NOTICE OF REVISION (NOR)

6. NOR NO.: 03BB020-01

8. DOCUMENT NO.: 923AS160

12. CONFIGURATION ITEM (OR SYSTEM) TO WHICH ECP APPLIES: BSU-86 A/B FIN ASSEMBLY

VIEW D-D
ROTATED 90° CW

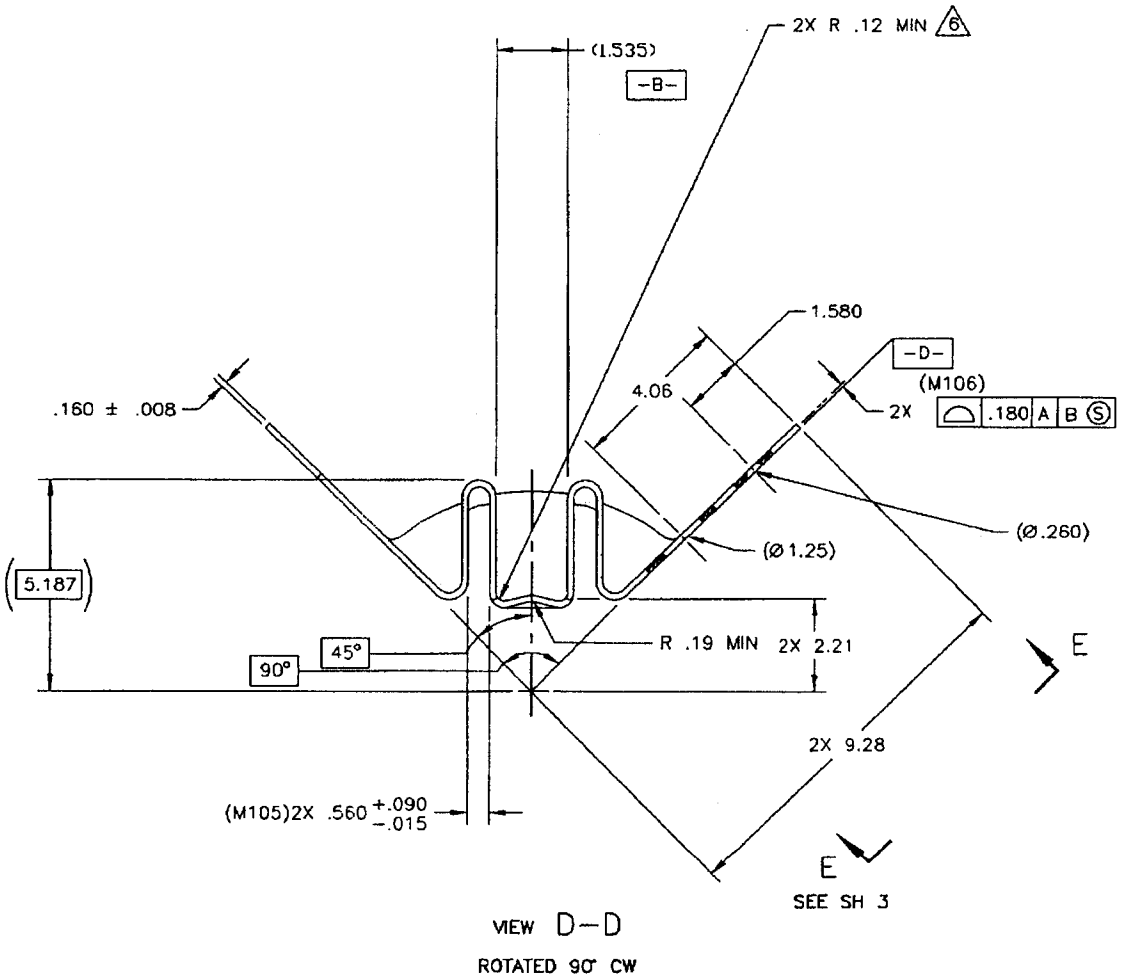
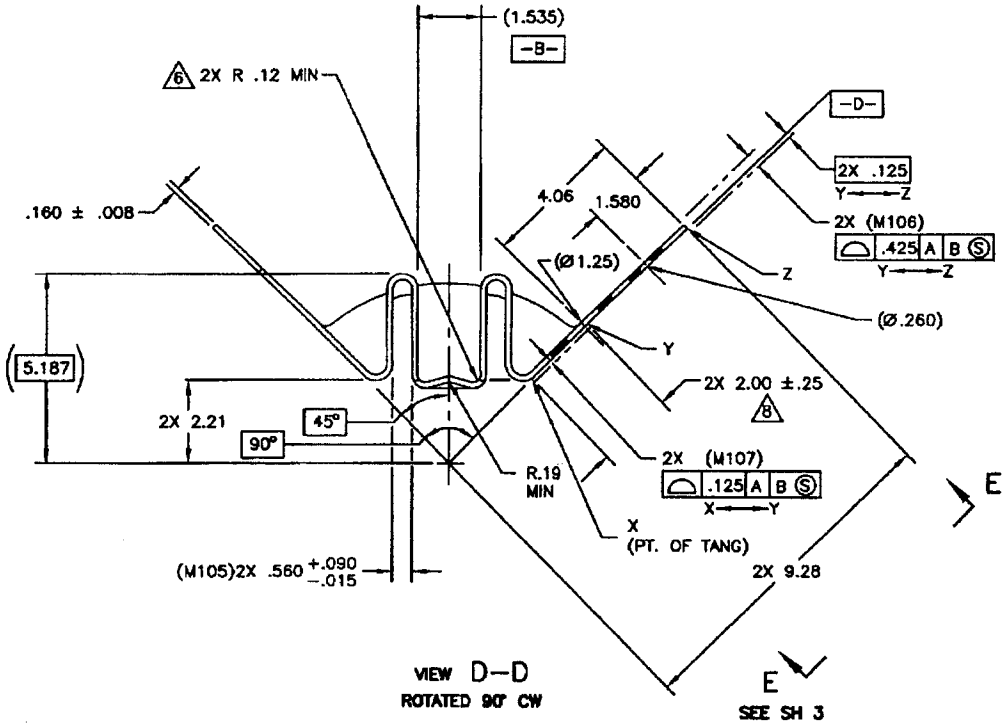
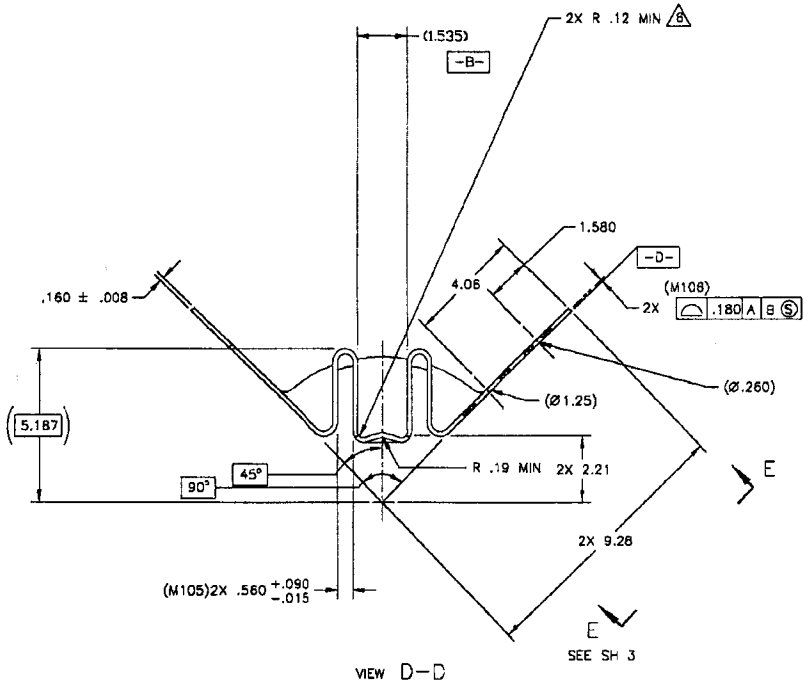
3. IN ZONE B/1-2, DELETE THE FOLLOWING FROM VIEW D-D:

(M106)
2X | ⌓ | .180 | A | B Ⓢ |

4. IN ZONES A-C/1-4, CHANGE DIMENSIONS IN VIEWS D-D:

VIEW E–E
ROTATED 45° CCW
SCALE 1/1

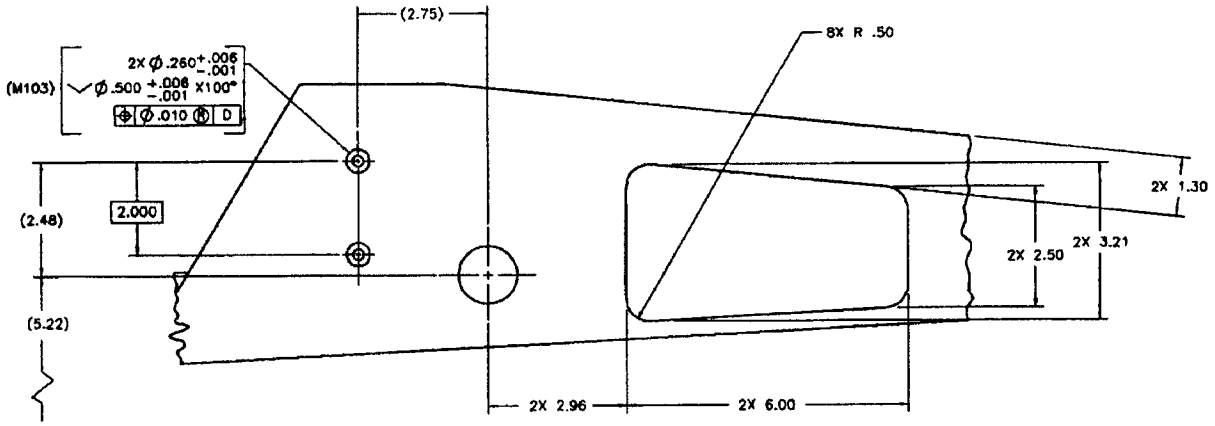
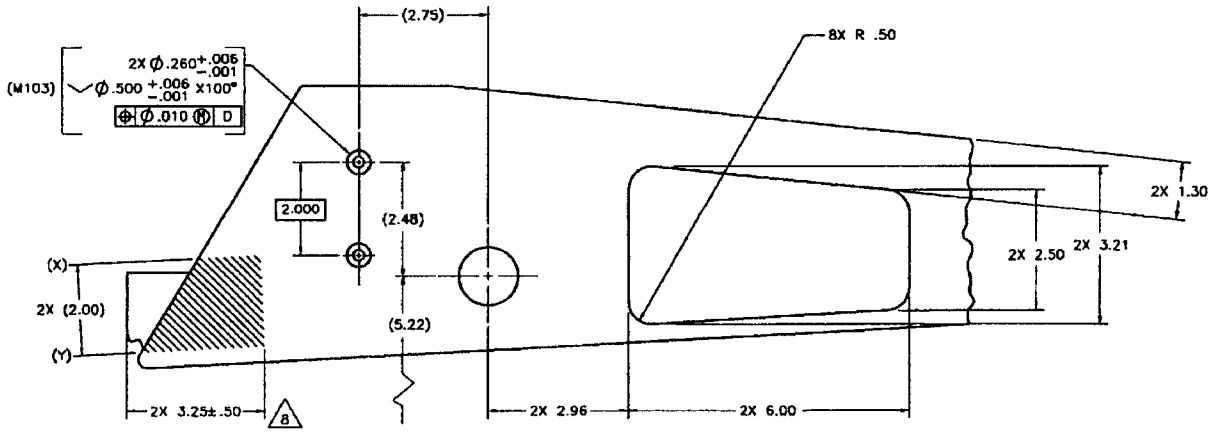
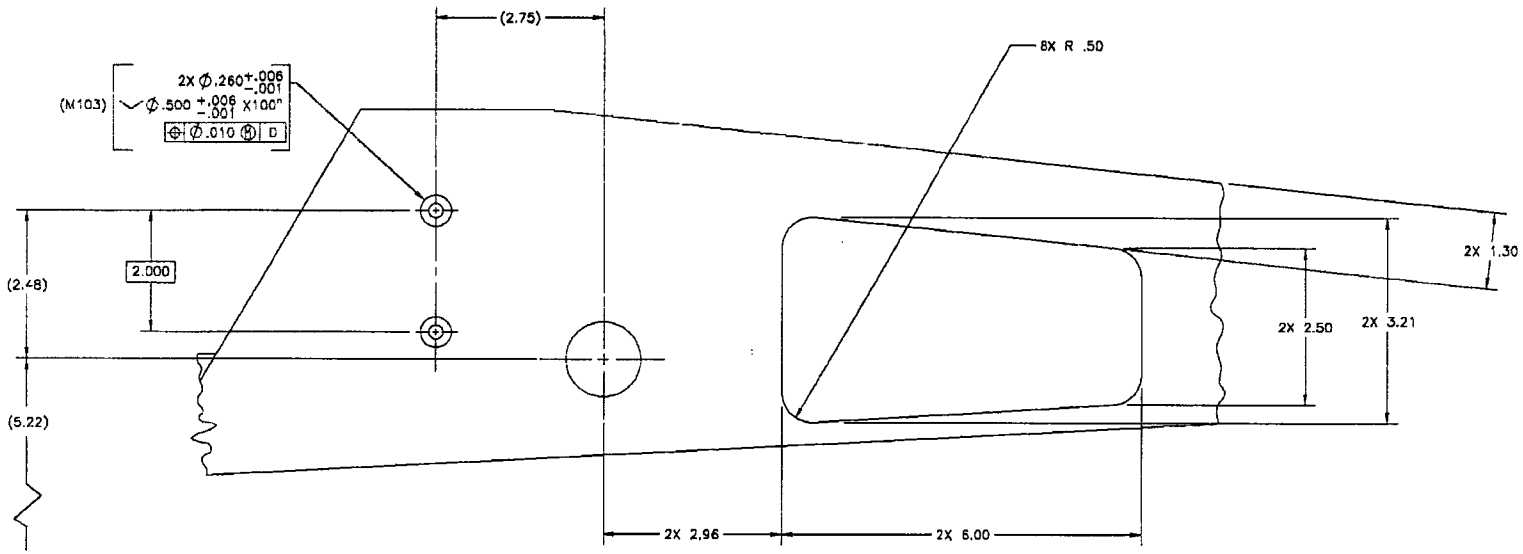
5. IN ZONES B-C/6-7, CHANGE VIEW E-E:

SIZE	CODE IDENT NO.	NAVAIRSYSCOM DWG NO.	REV
D	30003	923AS160	L
SCALE 1/2	UNIT WT	SHEET 1 OF 3

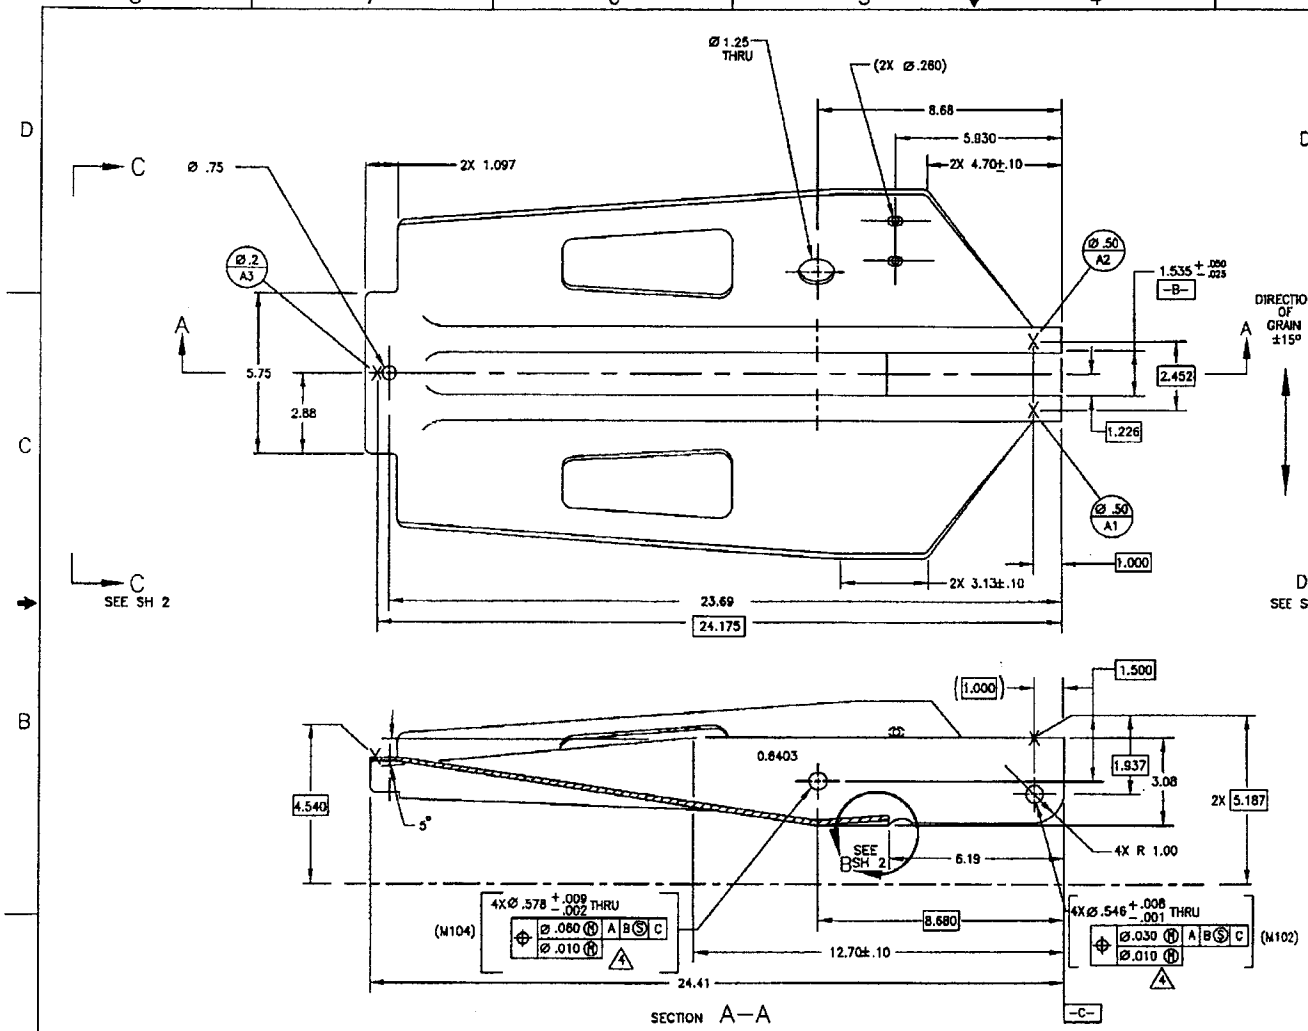
SHEET 1

1. IN NOTES, ADD THE FOLLOWING NOTE:

8. THE .125 PROFILE TOLERANCE APPLIES TO THE INDICATED AREA.

2. IN NOTES, ADD THE FOLLOWING NOTE:

9. ALL TRANSITIONS BETWEEN PROFILE TOLERANCE ZONES MUST BE SMOOTH.
